Conway Planning Commission Staff Report

7:00pm • March 13, 2017 • 810 Parkway Avenue

1A COVINGTON COMMERCIAL, PHASE 2 PRELIMINARY SUBDIVISION

CONWAY CITY PLANNING DEPARTMENT REVIEW COVINGTON COMMERCIAL, PHASE 2 PRELIMINARY PLAT SUBMITTED BY: COVINGTON STURGIS ROAD COMPLEX, LLC

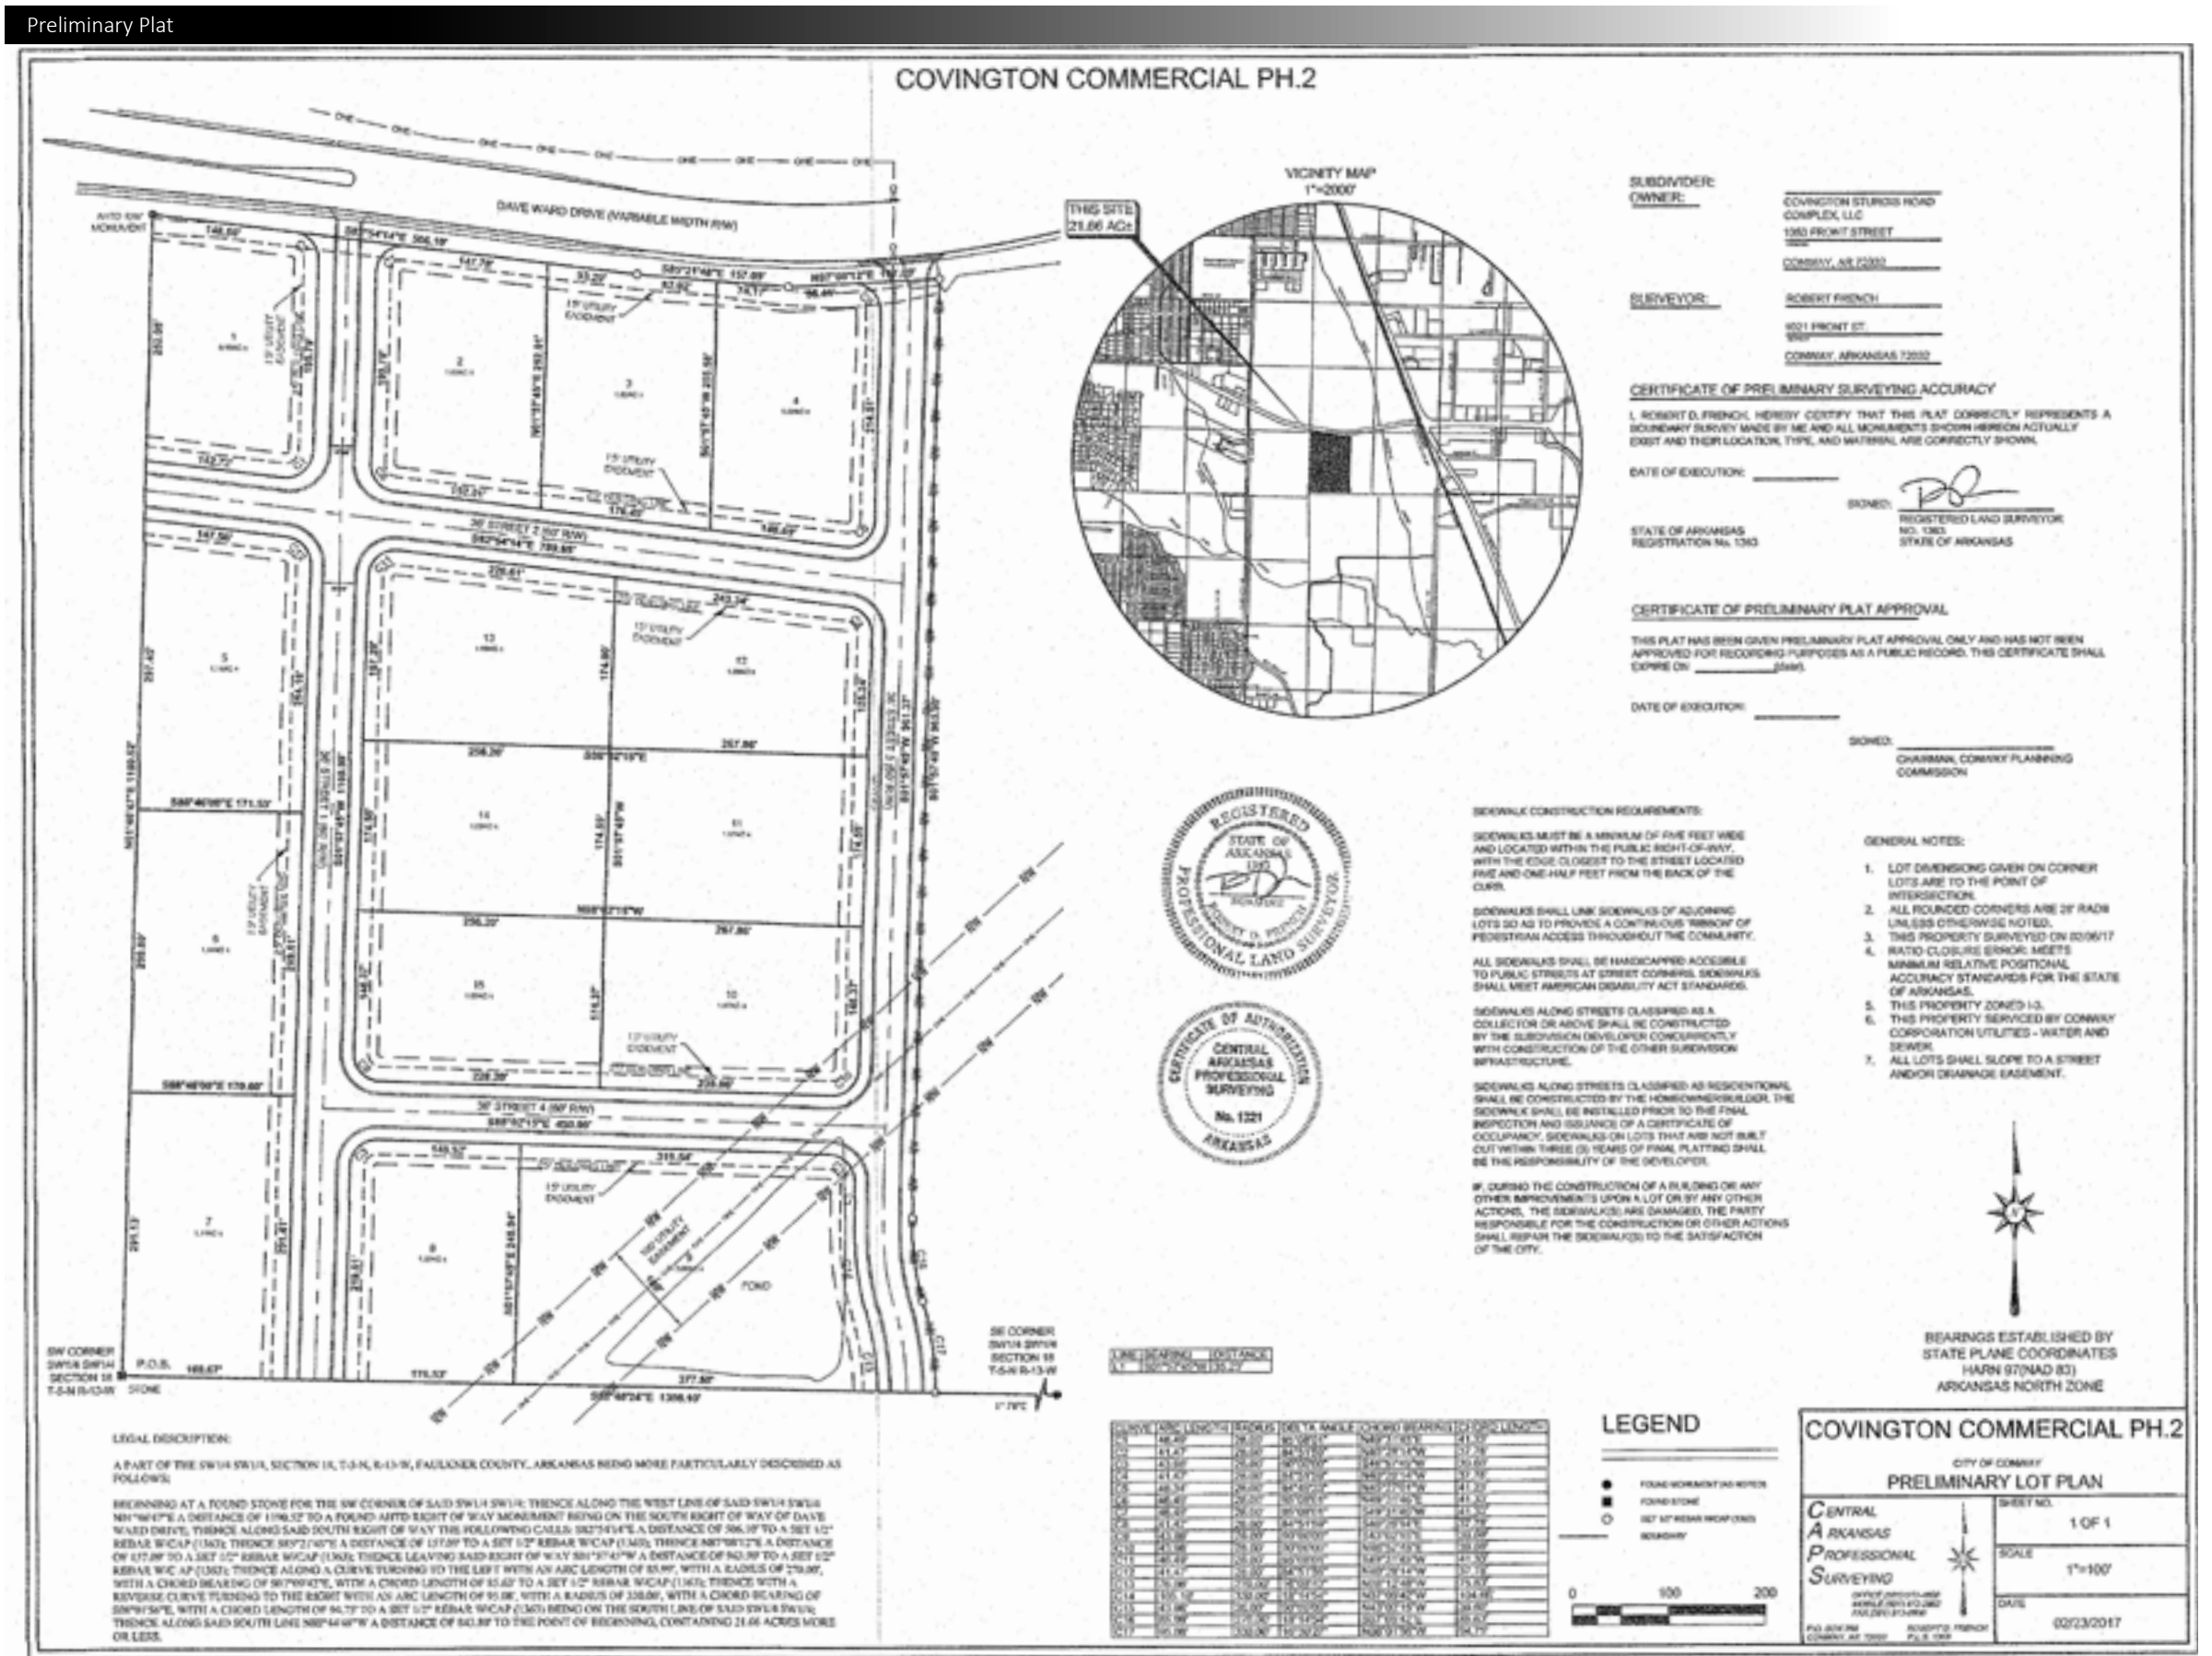
14. The proposed street layout should be integrated with the street system in the adjoining subdivisions. *With the absence of Master Street Planning for this area, City staff recommends approval of the preliminary plat contingent upon agreements with the Street Department on street alignment with adjacent property and proper ROW*

- dedication for streets.. **The Planning Commission must approve this request, or this condition must be corrected.**
15. The layout of streets shall conform to existing and proposed land uses for the area. Street 1/Dave Ward Drive intersection location conflicts with the Dave Ward Drive Median. Street 1 location should be moved so as to not conflict with the Dave Ward Drive median or the median must be extended to prevent a left hand turn. **The Planning Commission requires/does not require Street 1/Dave Ward Drive intersection location to be located to not create a left hand turn conflict or the median must be extended.**

17. The Planning Commission may authorize a new boundary street when the subdivider agrees to dedicate the entire right-of-way and construct all the required improvements. **Street 3 is a boundary street. The Planning Commission must approve this boundary street, or this condition must be corrected.**

18. Proper access in the form of stub streets or temporary dead end streets shall be provided to adjacent unplatted property unless, in the judgment of the Planning Commission, topographic conditions or physical constraints preclude reasonable provision of such access or alternate routes are or will be available in the future. **City Staff recommends Street 4 provide a stub street to the west. The Planning Commission requires/does not require this stub street, or this condition must be corrected.**

- 24. Double frontage lots other than corner lots fronting on two streets shall not be platted except under extreme circumstances, as may be approved by the Planning Commission. *Lots 1-4 are double frontage lots. **The Planning Commission must approve this request for double frontage lots, or this condition must be corrected.***

- 30. Subdivisions in the I-3 zoning district are not required to construct sidewalks or pay sidewalk in-lieu fees. *In the absence of a proposed use by the developer, and with the evolving development types on adjacent property, City Staff recommends construction of sidewalks on both sides of the streets for all streets and inclusion of Sidewalk notes on the plat.*

Site Plan

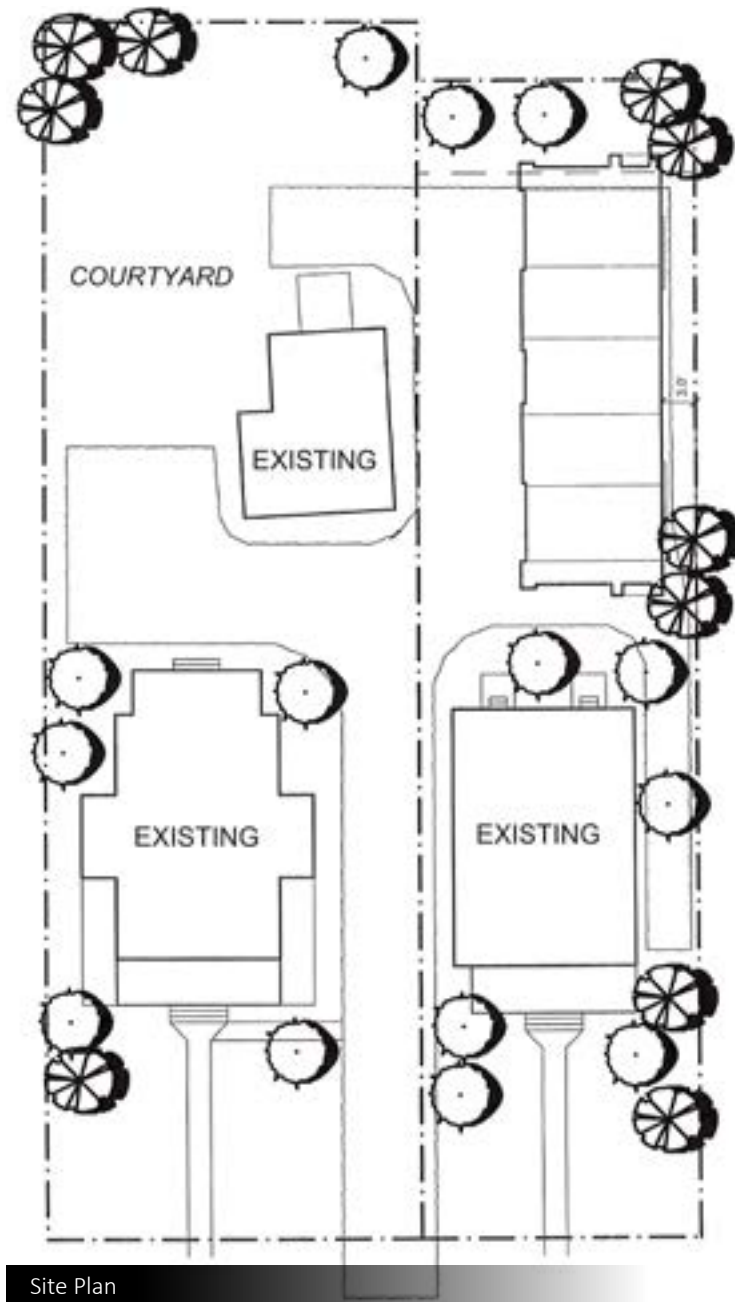
In general, Planning Staff is supportive of denser infill developments. However, this proposal is in the heart of a local certified historic district. One of the key roles of this historic district designation is preservation. There is no historic precedent or context for a development of this type and density within the Robinson District. The proposed structures are somewhat similar to “carriage houses” with a living unit above a garage. However, they are very large for carriage houses. There are several examples of small living units above a garage in the Robinson District and the Old Conway area. There is no precedent for multiple living units above multiple garages in Conway’s historic areas. The proposed new structures are 2 story in height. As proposed, the structures will be visible above the one story duplex’s rooftops. The developer has indicated that the proposed structures are very similar to existing garage apartment units at Centerstone Apartments at Dave Ward Drive and Moix Boulevard.

1. The PUD shall allow a maximum of **9 7** (or less) residential units. *(A possible compromise might be (1) additional residential unit per lot behind each existing duplex or (6) units maximum)*
2. The PUD shall have a maximum of **8 5** (or less) garage units. *(A possible compromise might be (1) additional 2-car garage per each existing duplex for a maximum of (2) 2-car garages)*
3. New structures must be situated to minimize visibility from Robinson Avenue.
4. Any signage must be approved by the Historic District Commission.
5. The PUD shall be generally developed as shown on site plan. Specific structure design, materials, landscaping, and variations from the submitted plan shall be allowed per Historic District Commission review. However, the density and intent of the site plan shall be followed.

6. Platting shall be required.
7. Setbacks, easements, etc shall be defined in the final development plan and PUD documents. Some dimensions, such as setbacks, shall be determined during Historic District Commission review.

Proposed Subdivision Layout

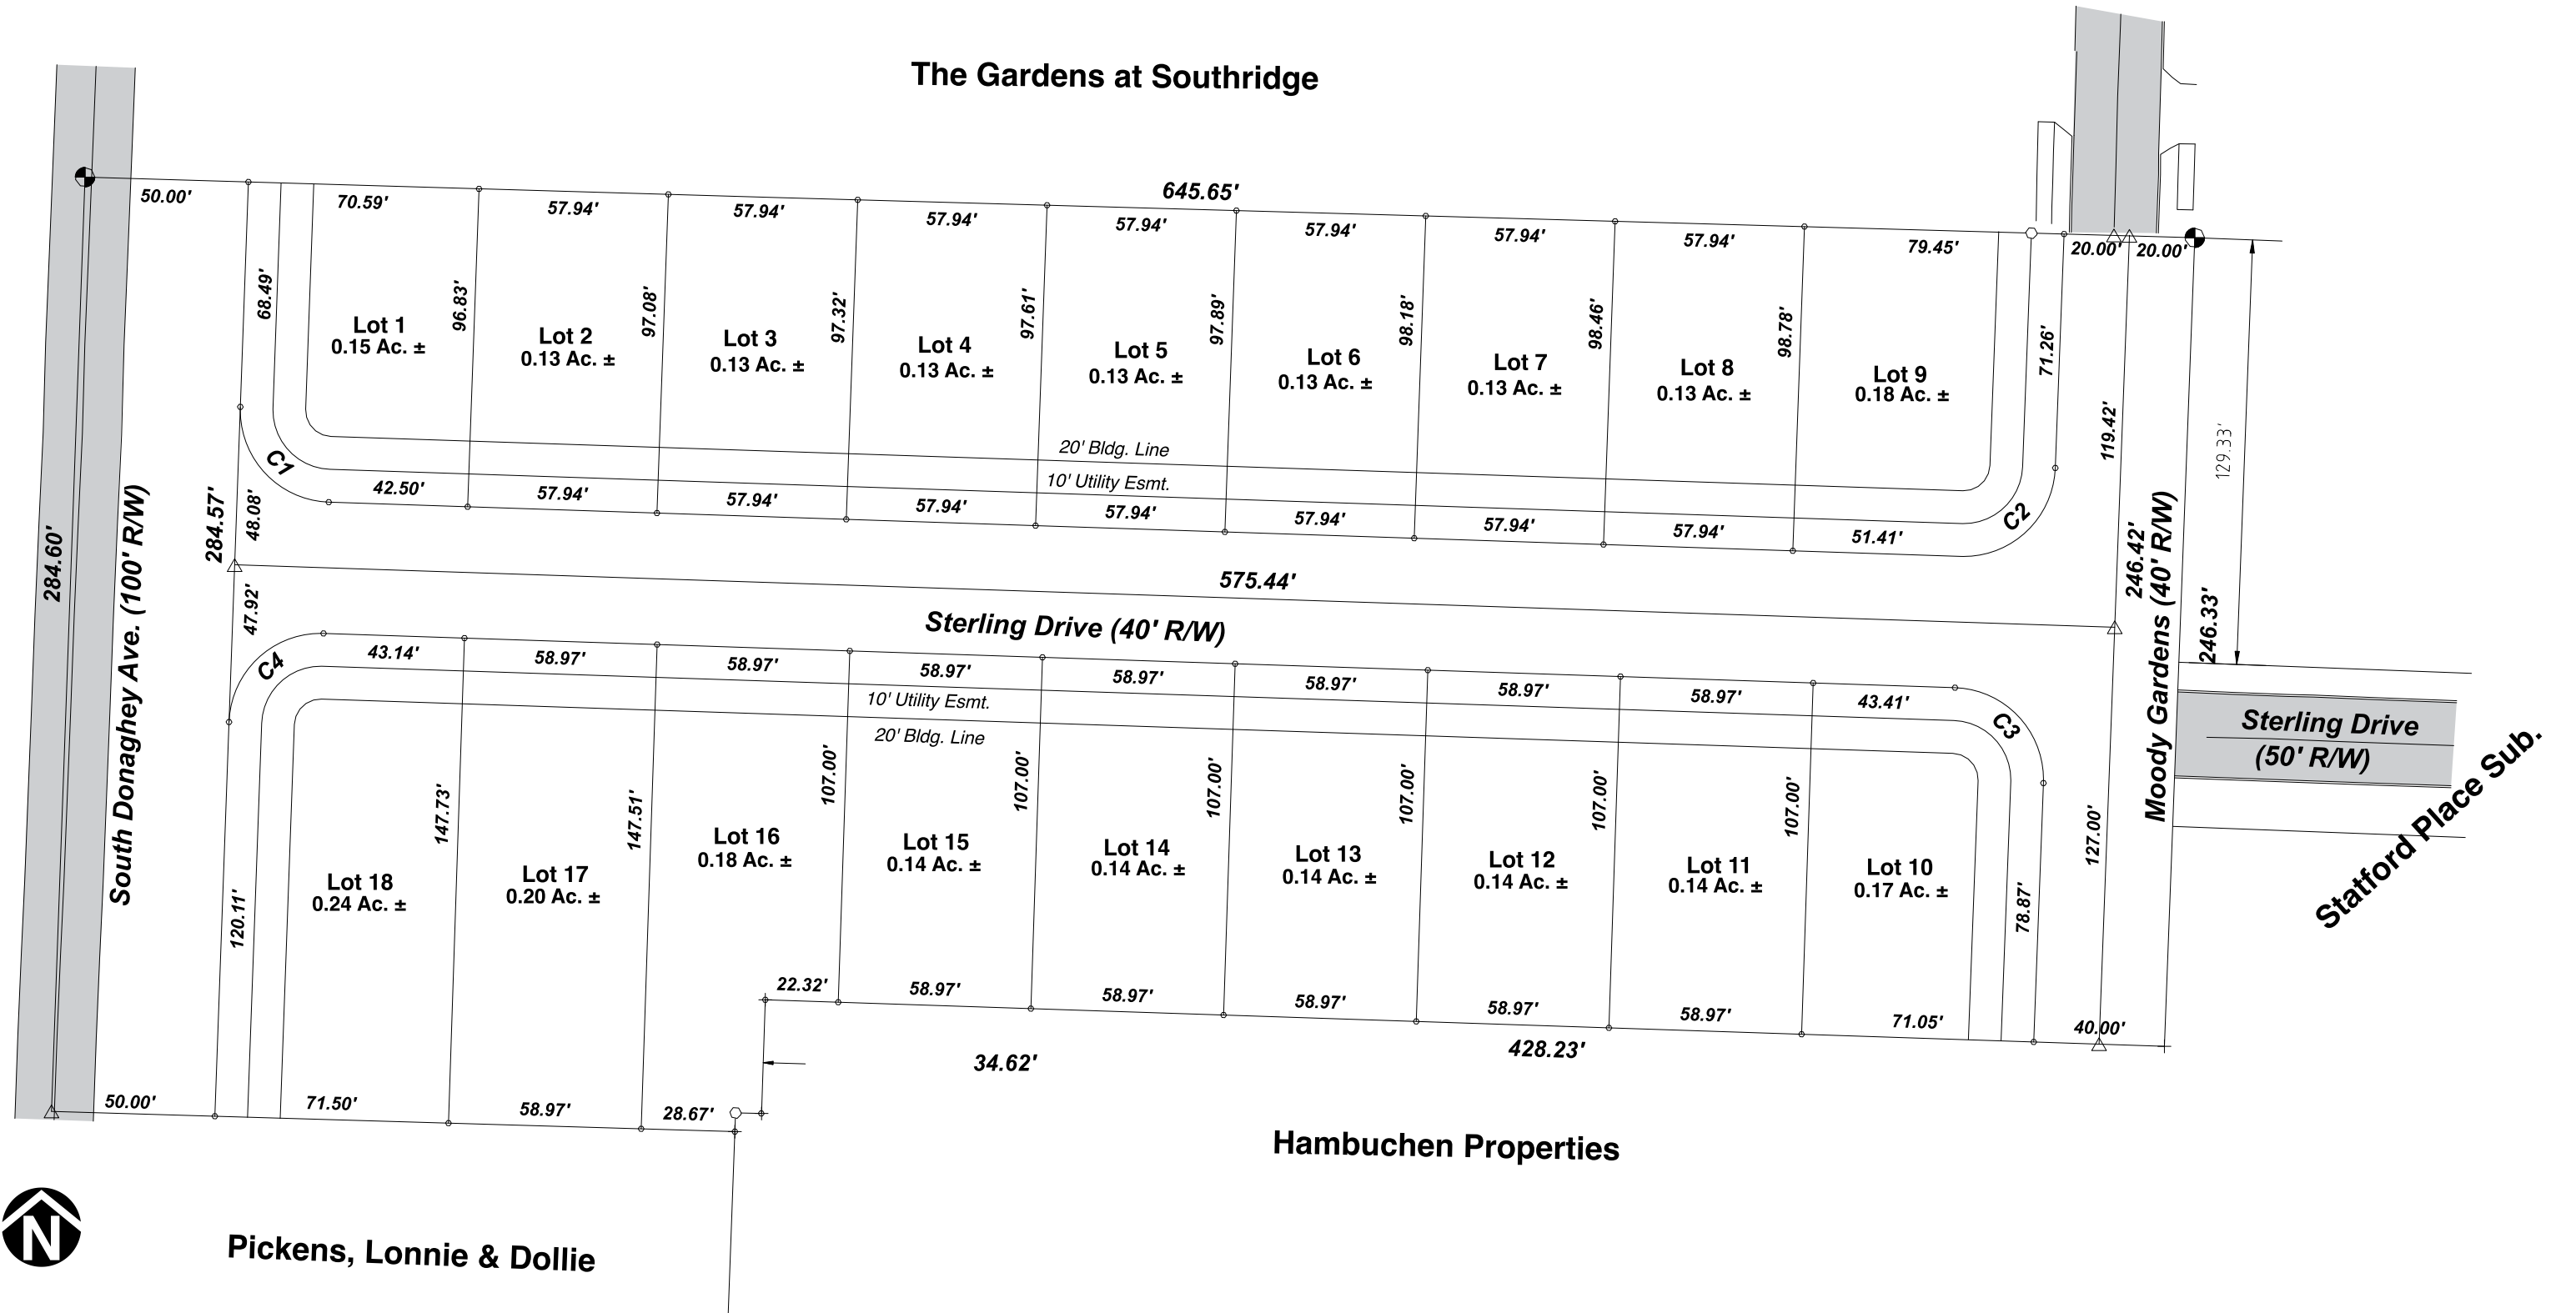
This project would allow the creation of a residential development with 18 single family homes. The smallest proposed lot in the PUD is .13 acre/5,662 s.f. The largest residential lot is .24 acre/10,454 s.f.

R-1 single family residential zoning requires a minimum lot size of .17 acre/7500 square feet. The average lot size of this development is .14 acre/6,098 square feet. The average proposed lot width is around 61 feet or 1 feet more than the minimal 60 foot R-1 lot width. Lot depth averages around 117 feet or 8 feet smaller than the typical 125 foot R-1 depth. If the property were developed as a typical single family residential neighborhood, 14 lots could be expected with a zoning variance for lot depth from the Board of Zoning Adjustment (Planning Commission). Without a lot depth variance, 10 single family homes could be expected.

- **Internal Street Network.** A PUD shall include an internal system of streets, parking aisles, and/or cross access drives that can safely and efficiently accommodate vehicular traffic generated by the PUD. *The proposed PUD would extend the existing Sterling Drive, although as proposed, it creates an unusual street alignment at Moody Gardens. The proposed streets would create additional area street connectivity. The proposed rights of way are 40 feet wide. A typical residential street right of way is 50 feet. These reduced rights of way will require a minimum 10 foot utility and pedestrian easement on each side of the right of way to provide adequate area for utility infrastructure and sidewalks. An additional 10 feet of street dedication shall be required along South Donaghey Avenue during the platting process. The intersection of existing Sterling Drive, the extension of Sterling Drive, and Moody Gardens creates an offset intersection. Additional review by the City Engineering and Planning Departments will be needed to create an efficient intersection. This could possibly be achieved through the use of a mini-roundabout.*

- **Sidewalk System.** Unless there are outstanding reasons that warrant otherwise, all internal streets within the PUD shall include pedestrian sidewalks. *The proposed PUD will include sidewalks along the new Sterling Drive and Moody Gardens. Sidewalks are also required along South Donaghey Avenue; however, due to the current open ditch construction, the City Engineer may prefer an in-lieu fee instead of sidewalk construction along Donaghey at this time.*

1. PUD shall be generally developed as shown on the submitted site plan. Minor variations from the submitted plan shall be allowed for technical reasons. However, the density and intent of the site plan shall be followed.
2. Additional review of street alignments by the City Engineering and Planning Departments will be needed to create an efficient intersection. Street alignments must be reviewed and approved by the Planning Commission during the platting process.
3. Platting shall be required. Any additional rights of way, sidewalks, etc. as required by the Subdivision Ordinance shall be dedicated and constructed. Any additional right of way per the Master Street Plan along South Donaghey shall be dedicated as part of the platting process.
4. Setbacks, utility/pedestrian easements, public rights of way, etc shall be defined in the final development plan, plat, and PUD documents.
